**City of Kingston  
Report to Heritage Properties Committee  
Report Number HP-26-009**

**To:** Chair and Members of Heritage Properties Committee  
**From:** Jennifer Campbell, Commissioner, Community Services  
**Resource Staff:** Kevin Gibbs, Director, Heritage Services  
**Date of Meeting:** May 20, 2026  
**Subject:** Application for Ontario Heritage Act Approval  
**Address:** 166 West Street (P18-993)  
**File Number:** P18-013-2026

DRAWING:  
ELEVATIONS

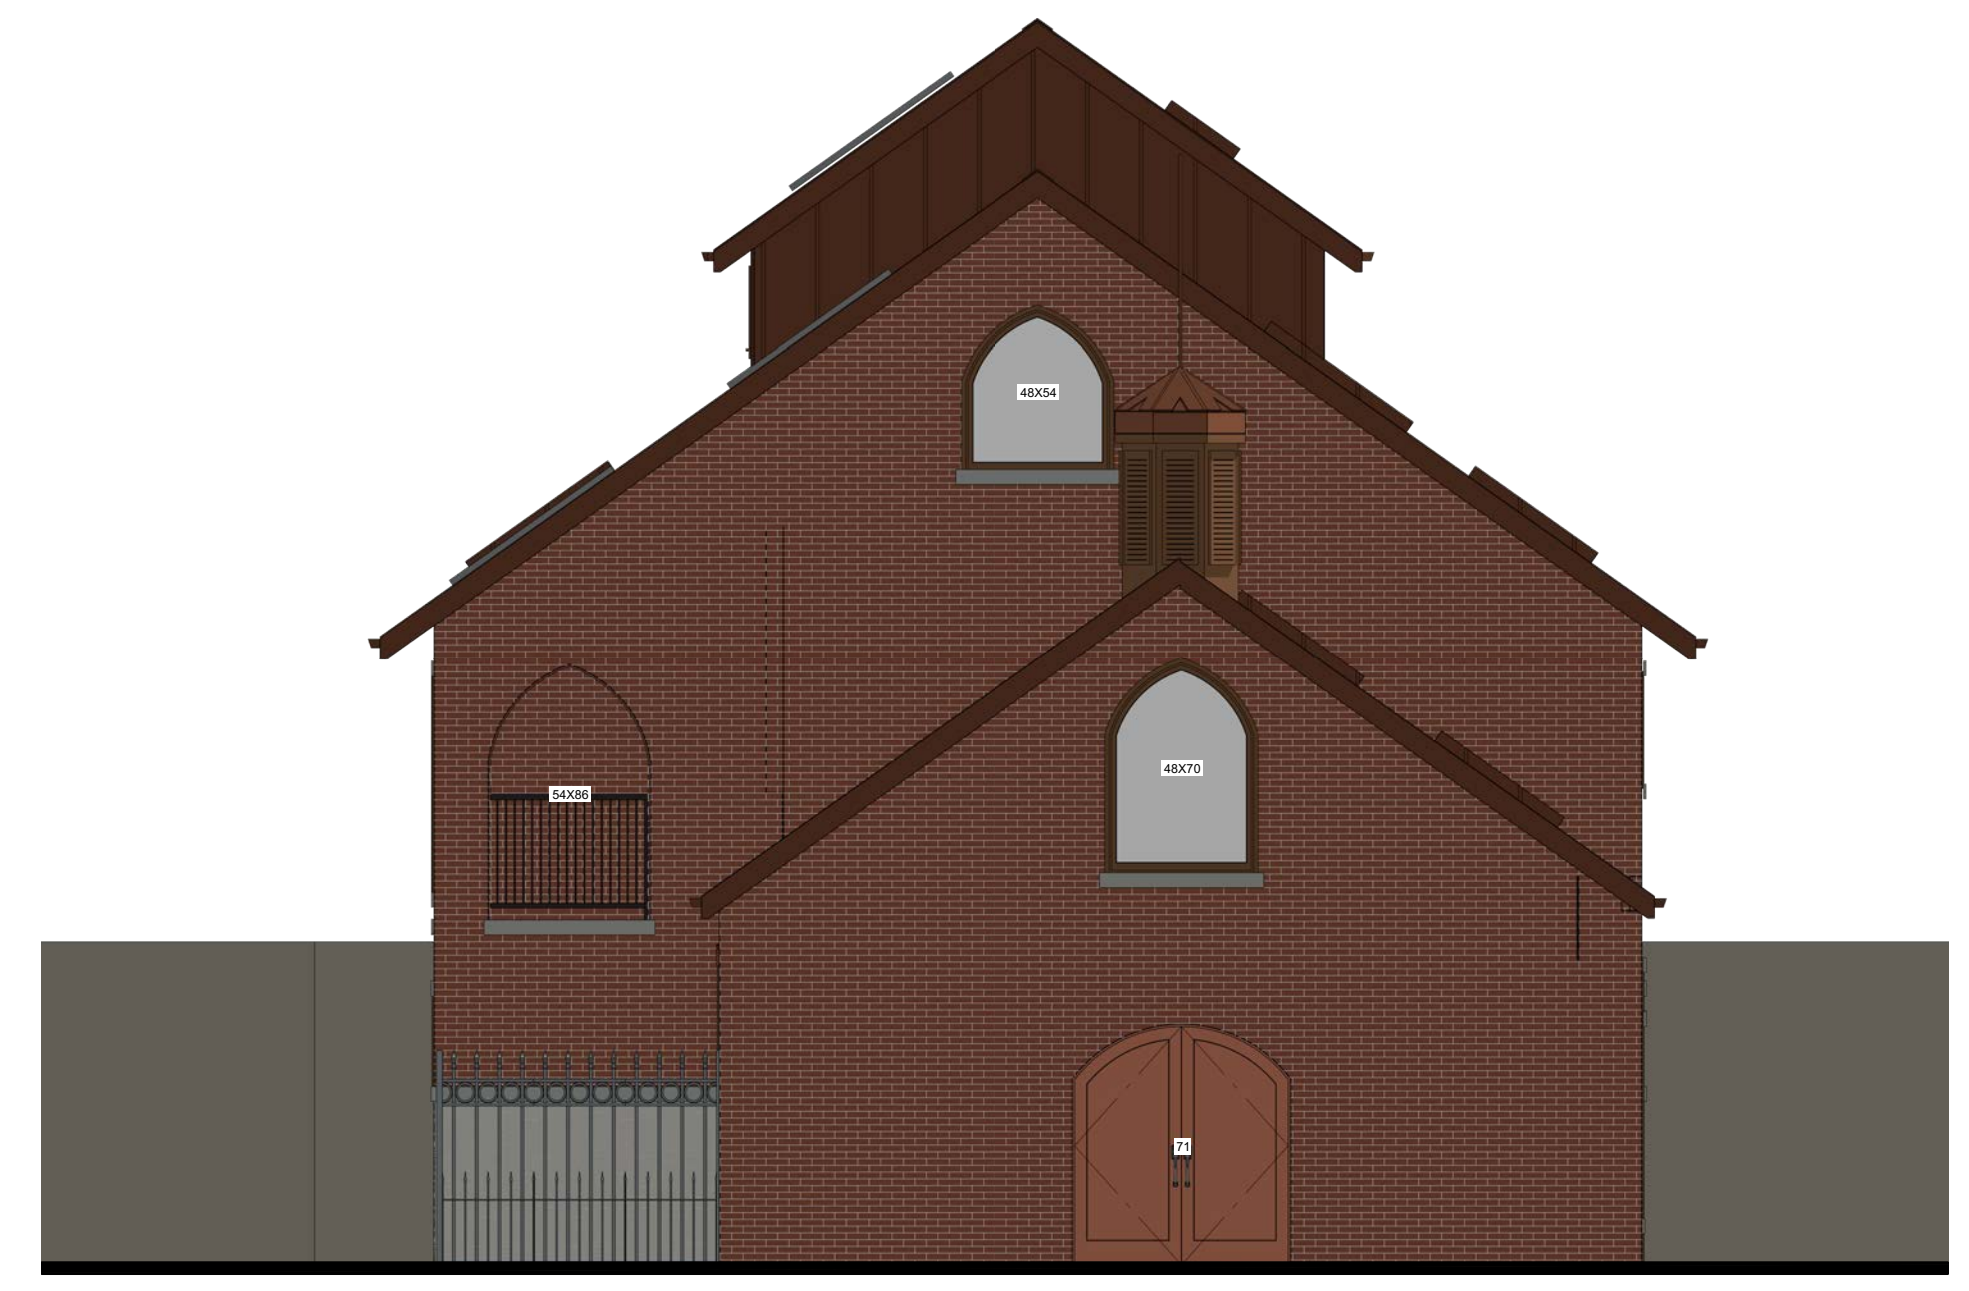
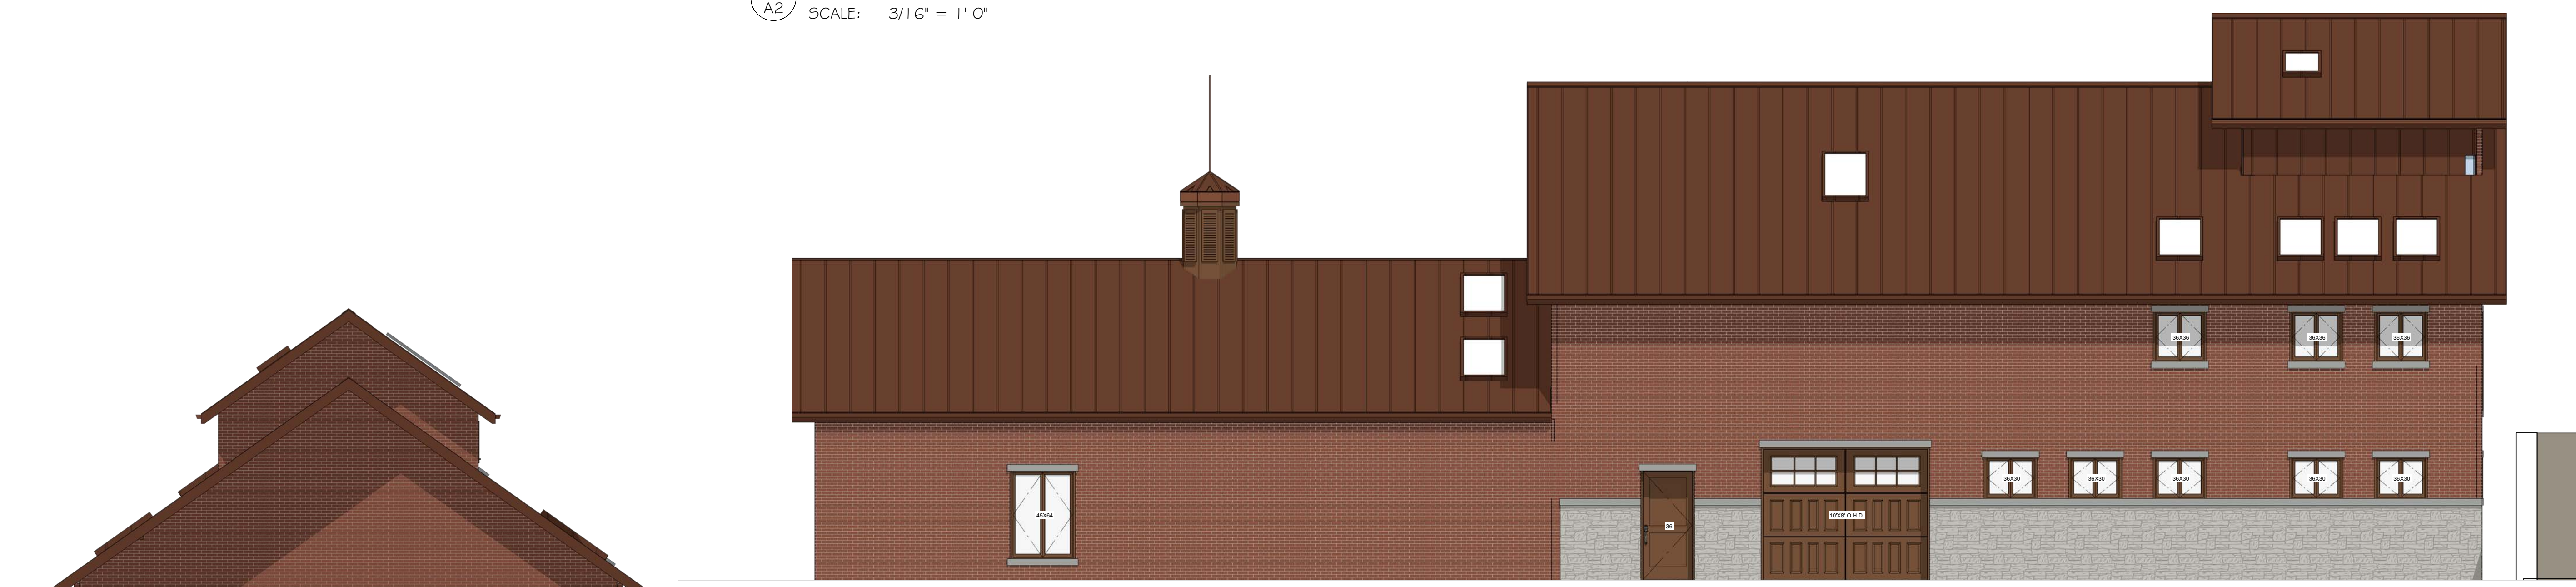
On the southern elevation of the front section, two in-swing casement doors are proposed within the existing openings. Comments from one member of the Committee questioned the appropriateness of two doors near each other along this elevation, noting that one door and two windows would be more appropriate. While staff agree with this statement, there are no historic photographs/plans available to substantiate this claim, nor are there any specific heritage policies to require it. A discretionary condition has been included to request the proponents to consider installing only one door and two sash windows along this elevation.

My only modest comment is about the arches on the new construction. I think those arches don't fit with the rest of the more restrained features. The arches look quite Mediterranean and could look better if they were simplified.

1. An important concern is the treatment of the 3 openings on the south side of the carriage house as they are very visible from the street. Originally there was a door opening and a window on this elevation, but a second doorway was added later with very poor workmanship. The application proposes to rebuild them and insert replacement doors and window. It seems a strange design to have two doors separated by six feet entering the new "great room". On the other hand, it would be desirable to have ample light into this room, so it would seem more reasonable to rebuild the second doorway as a window matching the one beside it. It should also be noted that the existing window on this elevation is a 2/2 vertical slider and is very likely original. Rather than replacing this window with a casement window as proposed, it would be much better from a heritage standpoint to stay with the original 2/2 style. Likewise, the replacement door should match the period of the carriage house which would probably have 4 panel doors. (See next comment on doors and windows).

2. The plans appear to show a number of new doors with 6 panels. Such doors are usually associated with "fine" houses and would seem out of character in a carriage house. From a heritage viewpoint it is preferred to maintain consistency of styles of new elements with the original building, and in this case 4 panel doors would seem more appropriate. Likewise, the application specifies the replacement windows as casement style. Such windows would be acceptable in the addition, but the carriage house should aim to be true to the original, and hence 2/2 vertical slider windows would be preferred there, although the small upper window on the east façade could be casement style. Similarly, the proposed exterior patio-style doors would be acceptable for the addition, but not for the highly visible door(s) on the carriage house south elevation.

1. The applicant shall amend their plans to reflect the use of 2 over 2 sash windows in the southern and northern elevations of the front (c.1892) section of the building, in place of the proposed casement windows;

5. The owners shall consider using a dark brown metal roofing, in standing seem profile, in place of the proposed copper roofing;
6. The owners shall consider amending their plans to reflect two sash windows and one door on the southern side of the front (c.1892) portion, instead of two doors and one window as proposed;

2 BUILDING SECTION  
A4 SCALE: 3/8" = 1'-0"

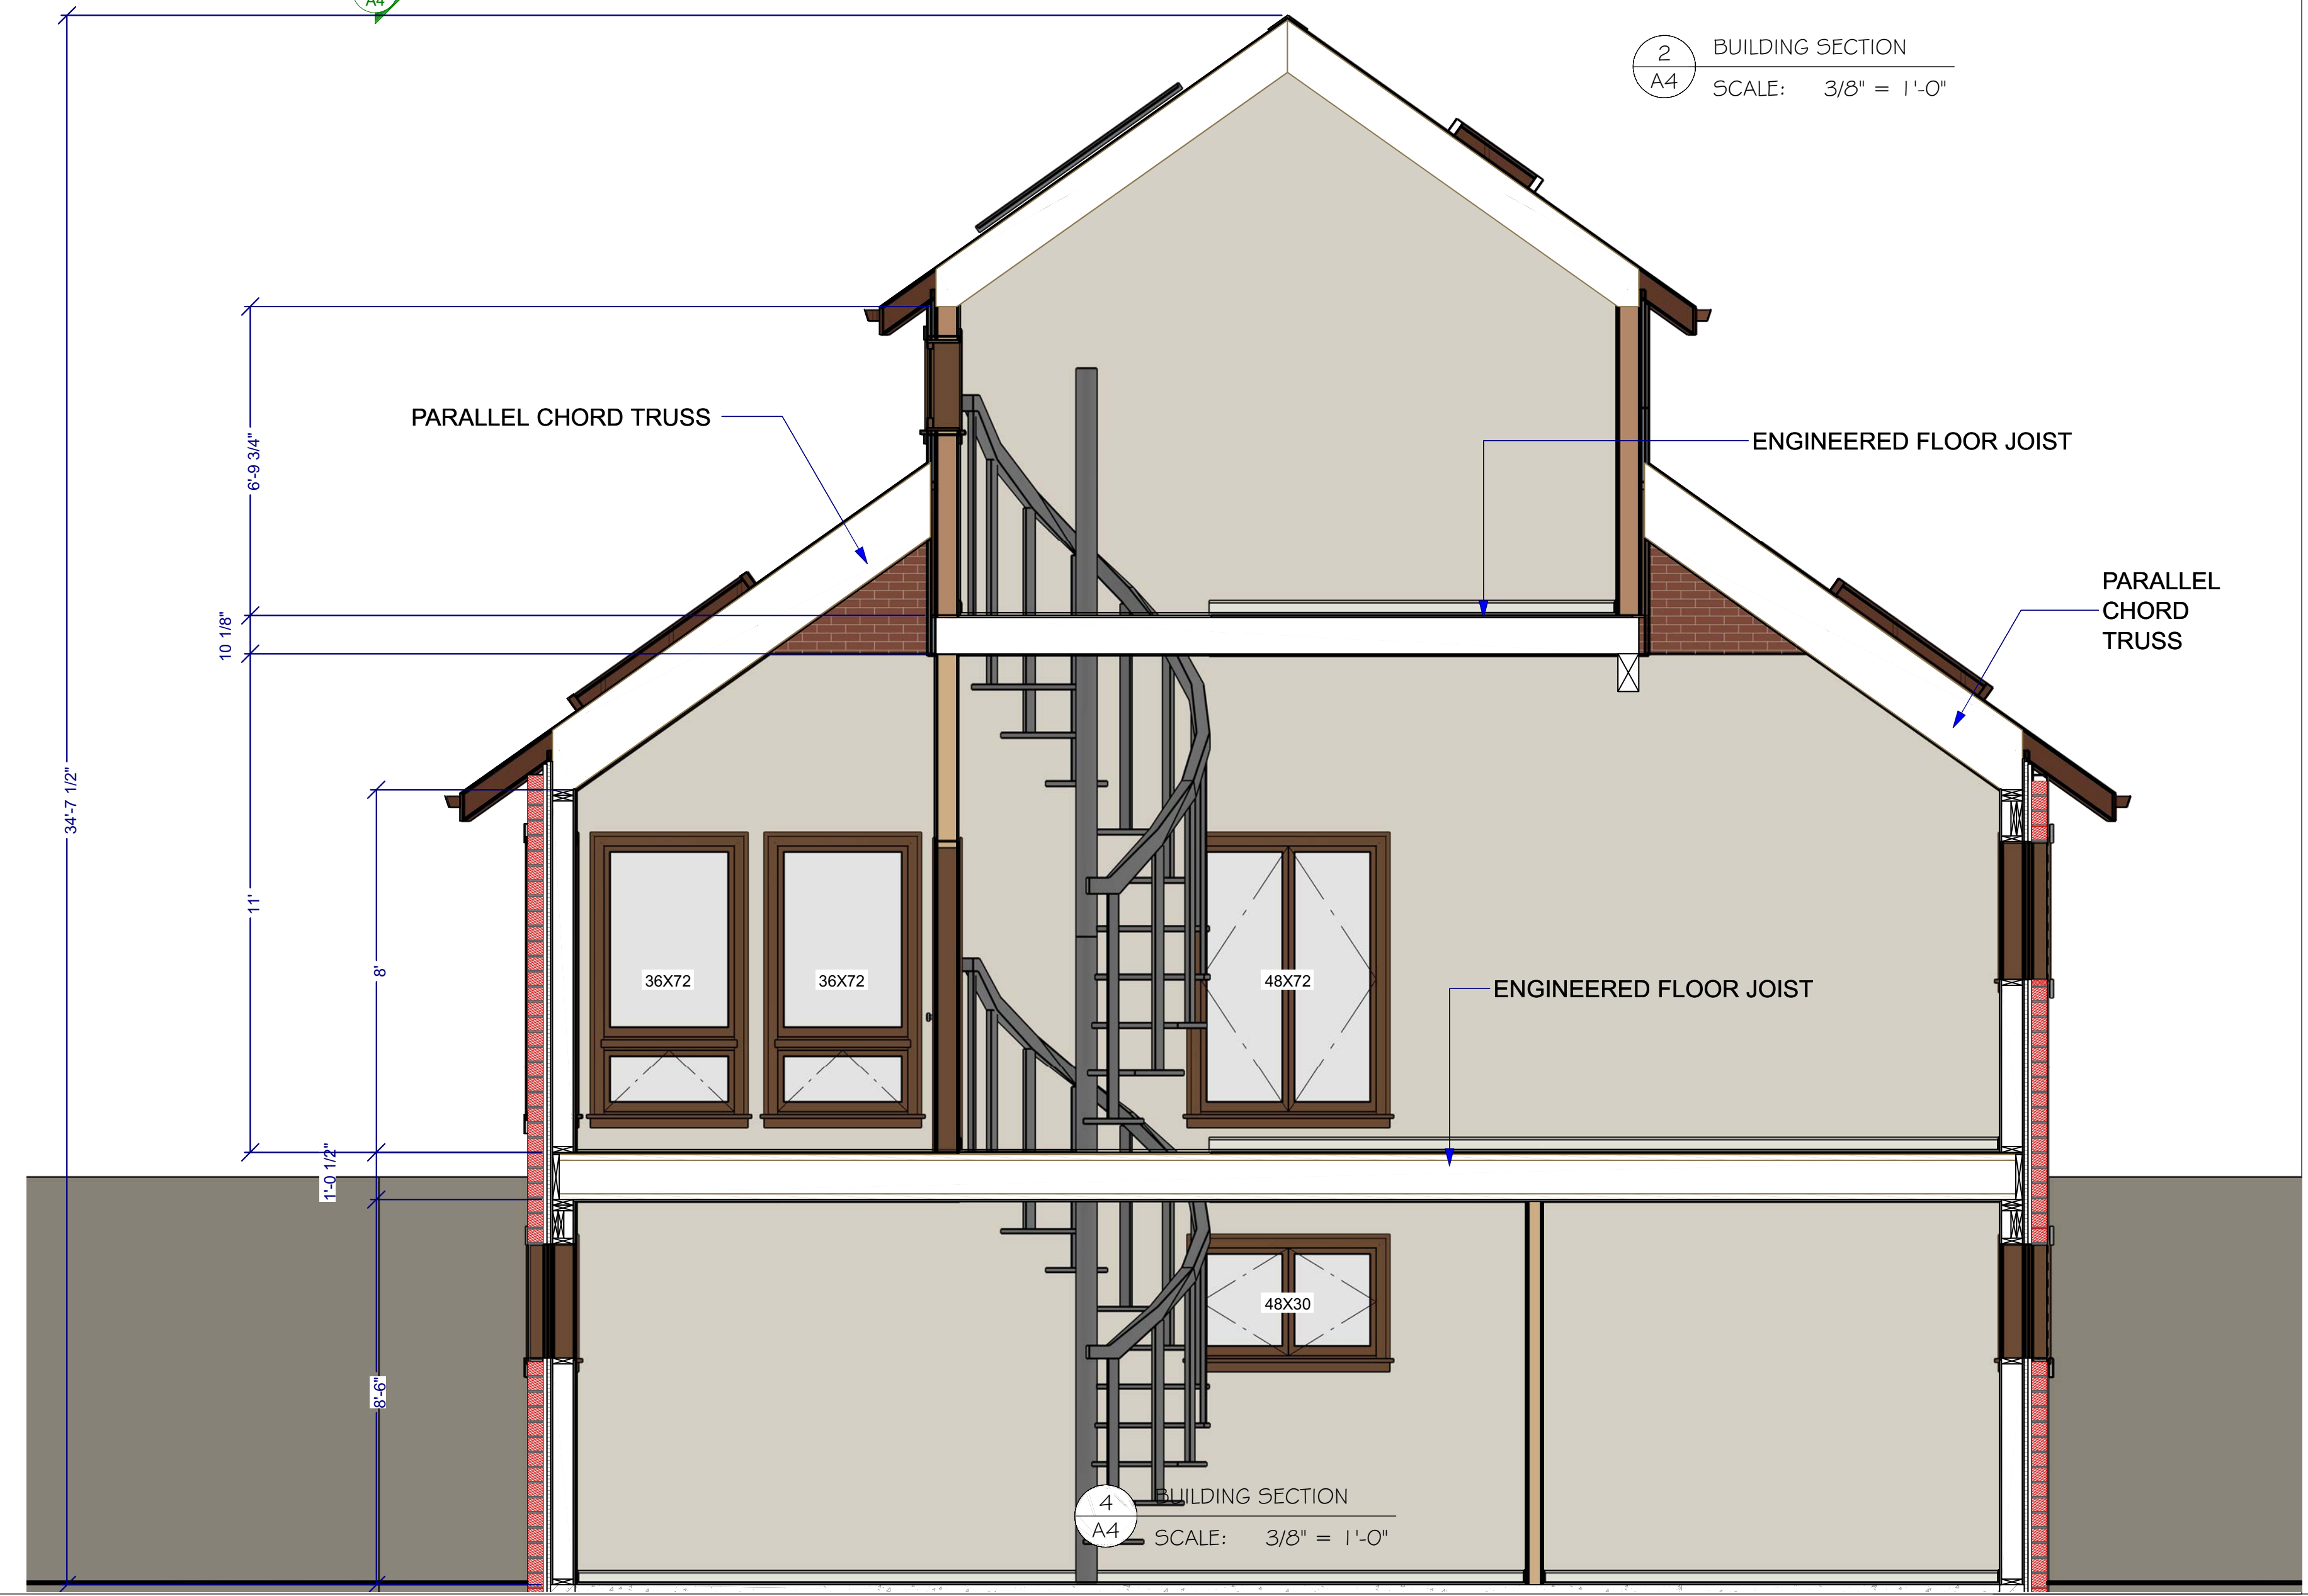
The original proposal included a 2-storey design, with a height indicated on the plans well below the maximum 10.7 metres to the mid-point of a peaked roof. The revised proposal indicates a 2.5 storey maximum height. As part of the building permit submission, the applicant should confirm that the proposed height complies with the maximum in the applicable zoning, which is the lesser of 10.7 metres or 3 storeys. The height in metres is measured as the vertical distance from finished grade to the average level between the eaves and highest point of the building (in the case of a sloped roof).
